Subject: Exelon Nuclear Texas Holdings, LLC
Victoria County Station Early Site Permit Application
Response to Request for Additional Information Letter No. 18
NRC Docket No. 52-042

RAI 02.05.02-11:

Figure 1a Houston demonstration site 10 Hz hard rock hazard curves: comparisons of several source models.

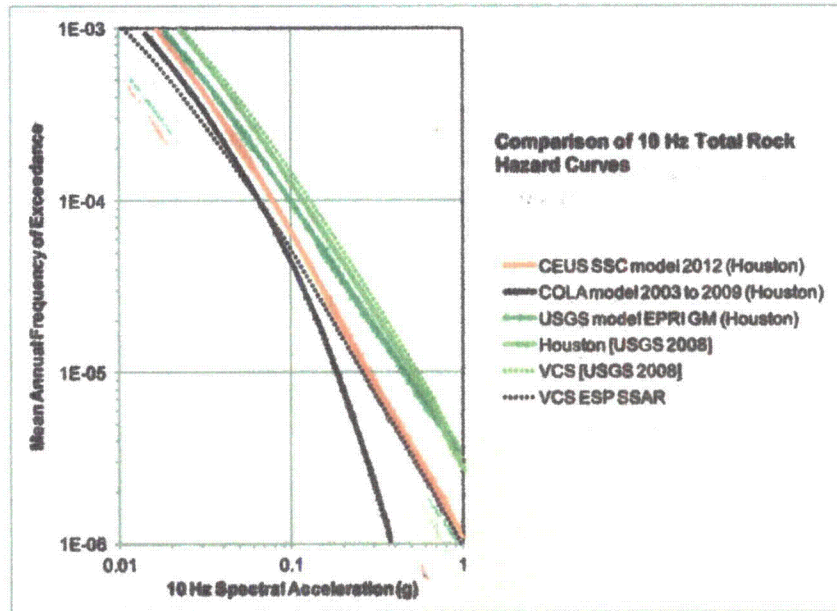
- a) Evaluate the potential impacts of the newly released CEUS-SSC model, with potential local and regional refinements as identified in the CEUS-SSC model, on the seismic hazard curves and the site-specific ground motion response spectra (GMRS). For re-calculation of the PSHA, please follow either the cumulative absolute velocity (CAV) filter or the minimum magnitude specifications outlined in Attachment 1 to Seismic Enclosure 1 of the March 12, 2012 letter "Request for information pursuant to title 10 of the Code of Federal Regulations 50.54(f) regarding recommendations 2.1, 2.3, and 9.3, of the near-term task force review of insights from the Fukushima Dai-ichi accident." (Agencywide Documents Access and Management System Accession No. ML12053A340).
- b) Modify the site-specific GMRS if you determine changes are necessary given the evaluation performed in part a) above.

The three panels of Figure 1 show comparisons of mean hard rock hazard curves from several source models for 10 Hz, 1 Hz, and PGA response spectral accelerations. The heavy solid lines (from Figures 8.2-3j, 8.2-3k, and 8.2-3l of NRC, 2012a) compare hazard at the Houston, Texas, demonstration site for the current CEUS SSC source model (heavy red line), the USGS model developed for the National Seismic Hazard Mapping Project (Petersen et al., 2008) (heavy bright green line), and a "COLA" model (heavy black line) that has been used for nuclear power plant licensing applications between 2003 and 2009. According to the CEUS SSC report, the "COLA" model is the EPRI-SOG (EPRI, 1988) model updated with more recent characterizations for the New Madrid fault source, the updated Charleston seismic zone, and an update of maximum magnitude values for some seismic sources near the Gulf of Mexico to reflect recent seismicity. Additional details of this "COLA" model are not available in the CEUS SSC report (NRC, 2012a). Calculations of hazard for all three of these models use the EPRI (2004, 2006) ground motion prediction equations (GMPEs) so that the differences in hazard presented among the three models are attributable to differences in the source models themselves.

Also shown in each of these three panels are three additional mean hazard curves that have been included as part of this RAI response. The two olive green lines are hazard curves for the Houston (solid) and the VCS (dotted) sites from the USGS source model and USGS GMPEs. The difference, then, between the solid olive green and solid bright green hazard curves should arise from GMPE differences [EPRI (2004, 2006) vs. Petersen et al. (2008)]. The difference between the two olive green lines [solid and dotted] arises from their different locations within the USGS model.

The third additional line (dotted black line) in each panel is the hard rock VCS ESP SSAR hazard curve for that frequency. Since both the black dotted and heavy black solid hazard curves use the EPRI (2004, 2006) GMPEs and both use updated versions of the EPRI-SOG model these two lines might be expected to match each other closely. This is the case, in fact, only for the 1 Hz hazard curves. The reasons for the differences for the hazard curves at higher frequencies are unknown – and pertinent additional details of the "COLA" model are not available in the CEUS SSC report (NRC, 2012a) – but could be caused by details of the geographic distribution of local seismic activity rates and/or difference in lower bound magnitudes used in the two analyses.
